Staff Amended (5/25/89)  
**CITY PLANNING COMMISSION**

- APPLICATION:**
- A. Negative Declaration
  - B. Tentative Map to divide one lot into two on 4.8+ vacant acres in the Light Industrial-Review (M-1 SR) zone
  - C. Plan Review of a 12,000 square foot regional parts warehouse and office building
  - D. Variance to waive the City's standard surfacing requirement for a portion of the storage area for a proposed regional parts warehouse

**LOCATION:** Northwest corner of Bell Avenue and Strauss Drive

**PROPOSAL:** The applicant is requesting the necessary entitlements to construct a 12,000 square foot regional parts warehouse in the area known as the I-80 Industrial Park.

## TENTATIVE PARCEL MAP

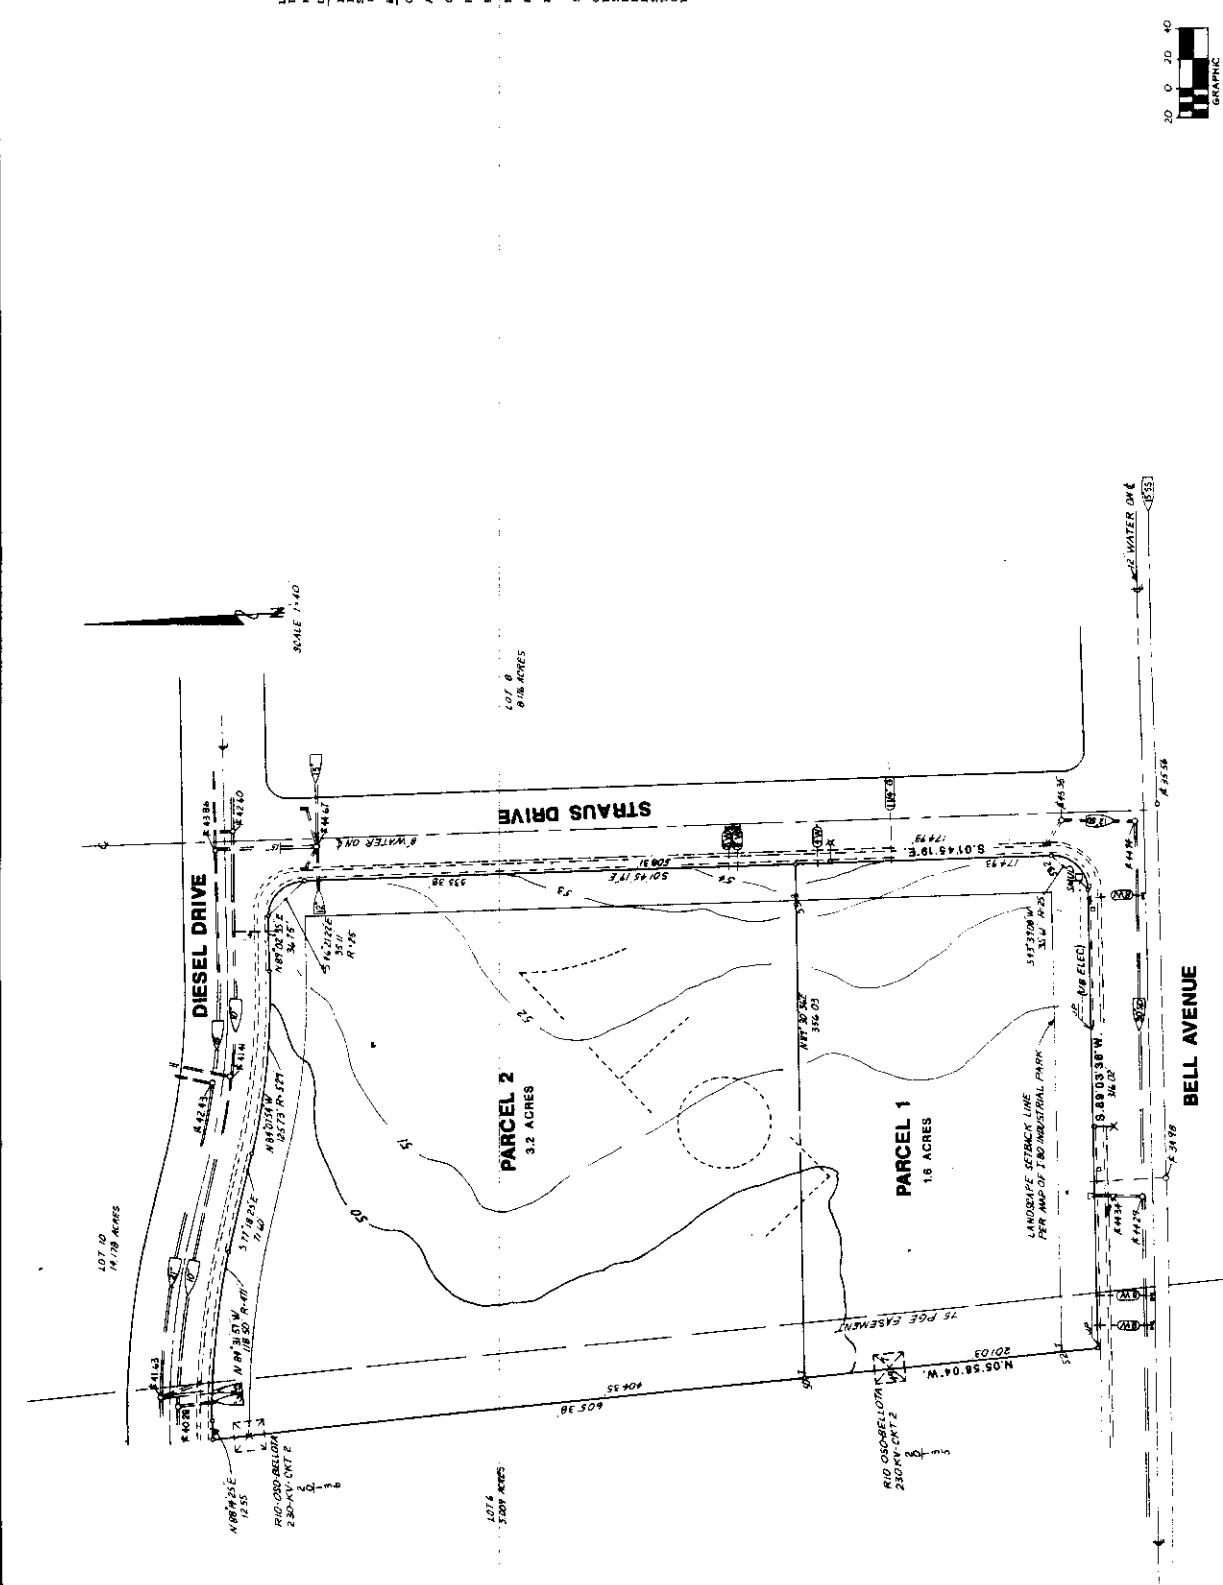
The purpose of the "R" review in the area west of McClellan Air Force Base is to assure adequate infrastructure improvements, i.e., water, sewer, storm drainage, and roadways. The tentative map has been conditioned to require separate water and sewer be provided to each parcel. The roadways in this area (I-80 Industrial Park) have been developed under previous tentative map approval. The zoning also requires a 25 foot landscape setback along all public street frontages.

1. Pay off existing assessments, or file the necessary segregation requests and fees to segregate existing assessments;
2. Show all existing easements;
3. Provide separate sewer and water services to each lot prior to obtaining building permit;

4. Dedicate a 12 1/2 foot public utilities easement along all streets, if not existing. Place the following note on the Final Map and in the deeds to affected parcels: "Land use is restricted within electric transmission easement. Contact PG&E Land Department for information."

# SITE PLAN

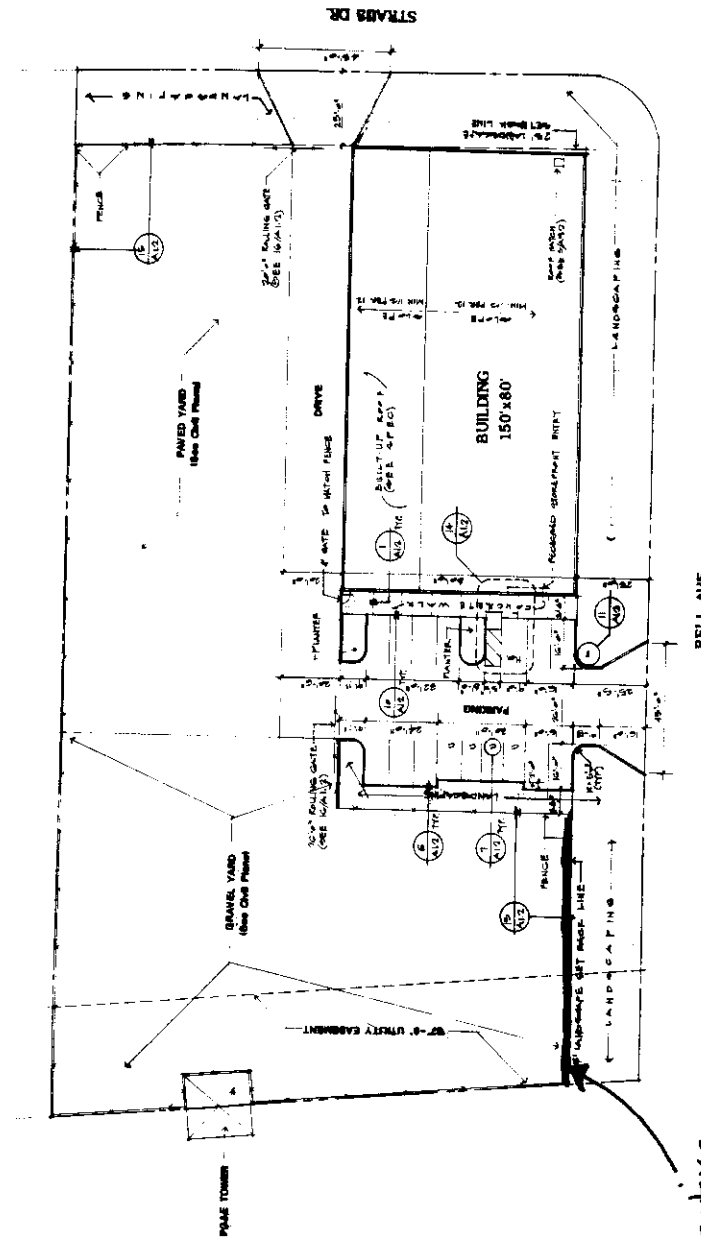
The applicant has not submitted a landscape plan as part of the proposal. Designated landscape areas have been indicated on the site plan including the required 25 foot landscape setback adjacent to Bell Avenue and Strauss Drive. Staff recommends the following items be incorporated into the landscape plan:

The site plan indicates fencing around all of the storage area. The type of fencing is not indicated. Staff recommends a 6 foot high chain link fence with vinyl slats around the perimeter of both the paved and gravel storage yards.

As noted previously, the applicant is requesting a variance to waive the City's standard surfacing requirement for a portion of the storage yard. Planning Staff is aware of the damage that construction vehicles can inflict on an asphalt or concrete surface and in the past has recommended the waiver of the City's standard surfacing requirement for other heavy equipment storage yards in the City. However, staff wants to insure that the waiver of the standard surfacing will not result in excessive dust, leakage of contaminants into the soil, deterioration of the public right-of-way, or cause the site to have an unattractive appearance. Therefore, staff recommends all equipment repair areas and driveway entrances be paved in accordance with City standard. The remaining equipment storage area can be surfaced with gravel. Drainage for the gravel area must receive the approval of the City Public Works Department, Fire Department, and City/County Health Department. Staff also recommends a 6 foot high solid decorative masonry wall along the Bell Avenue frontage to alleviate the visual impacts of the gravel surfaced storage area.

2. A revised landscape, shading, and irrigation plan shall be submitted and subject to Planning Staff review and approval prior to issuance of building permits. This plan shall indicate:

4. The applicant shall construct a 6 foot high decorative masonry wall along the Bell Avenue frontage.
5. Drainage for the gravel vehicle storage area shall comply with the requirements of the City Public Works Department, the Fire Department, and City/County Health Department.

# ELEVATIONS

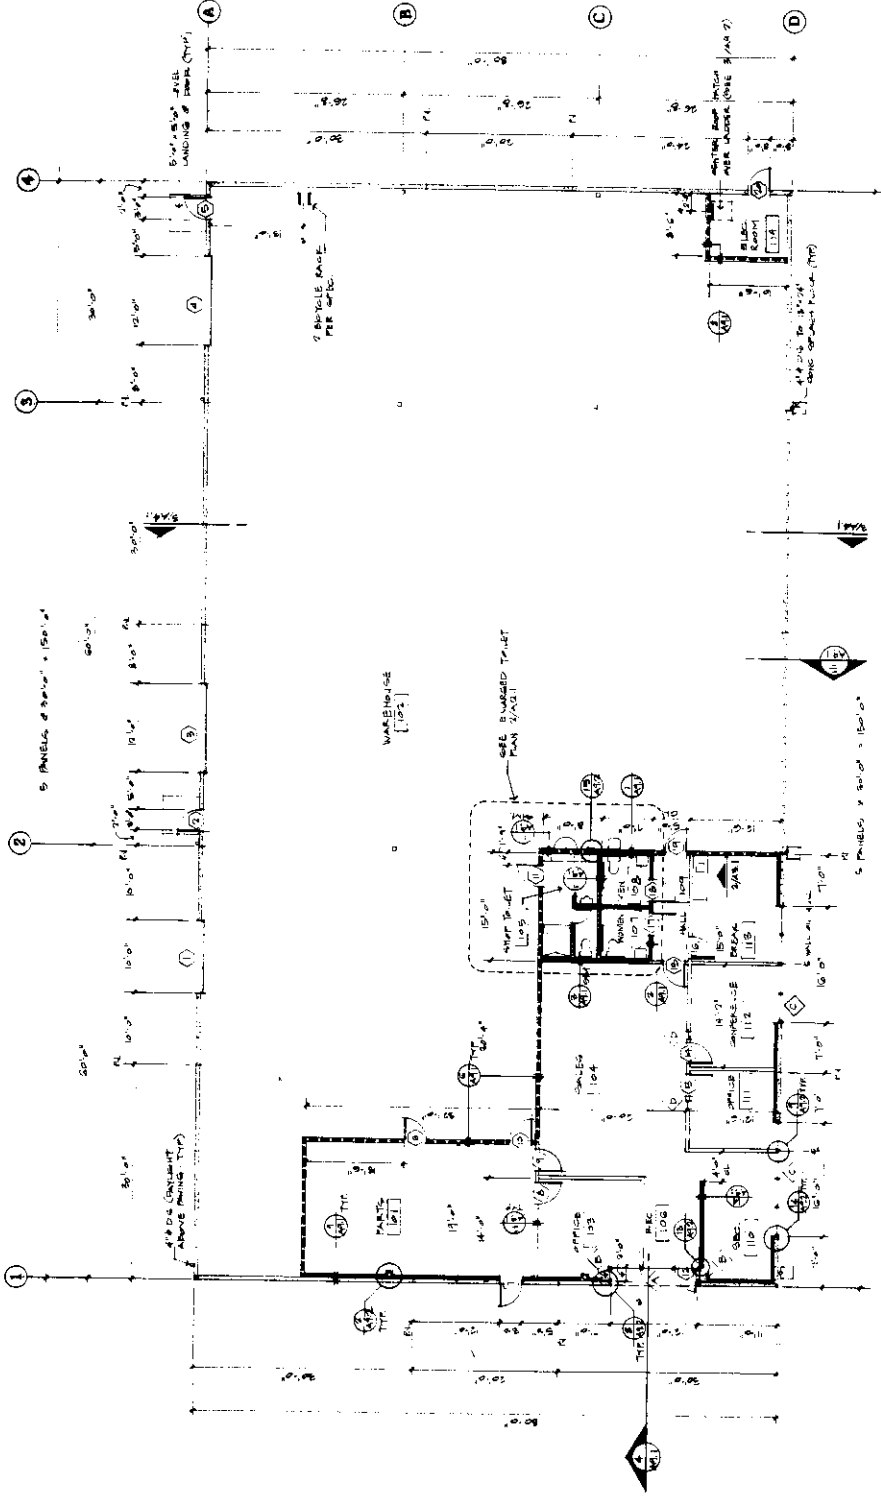
The submitted building elevations indicate tilt-up concrete panels with painted formliners and accent reveals. The formliner and reveal lines extend around all sides of the building. Roll up doors are located on the north elevation which opens up to the paved yard area. The concrete panels will be painted gray with the formliner and reveal lines painted pastel colors to accent the gray. The design and materials of the proposed building is very similar to the buildings approved and under construction adjacent to the north. However, the south elevation which faces Bell Avenue is highly visible and should be aesthetically improved. Staff suggests some additional detailing to provide visual interest to this facade. This could be accomplished through the use of awnings or recessing or extending the glass storefront window systems. The applicant should revise the south elevation including a decorative element subject to Planning Staff review and approval.

- h. Plants and/or shrubbery should be installed adjacent to the south building elevation;
- i. The parking area must meet the City's 50 percent shading requirement;

1. The applicant shall revise the submitted building elevation to add an element of architectural interest through the use of recessed or extended window sections or awnings to the south facade of the building. The revised elevations shall be subject to Planning Staff review and approval prior to issuance of building permits.

- h. Plants and/or shrubbery adjacent to the south building elevation;
  - i. Shrubs along the fences fronting the public streets.
3. The proposed chain link fence located around the perimeter of the equipment storage area shall utilize vinyl slats as a screening device.
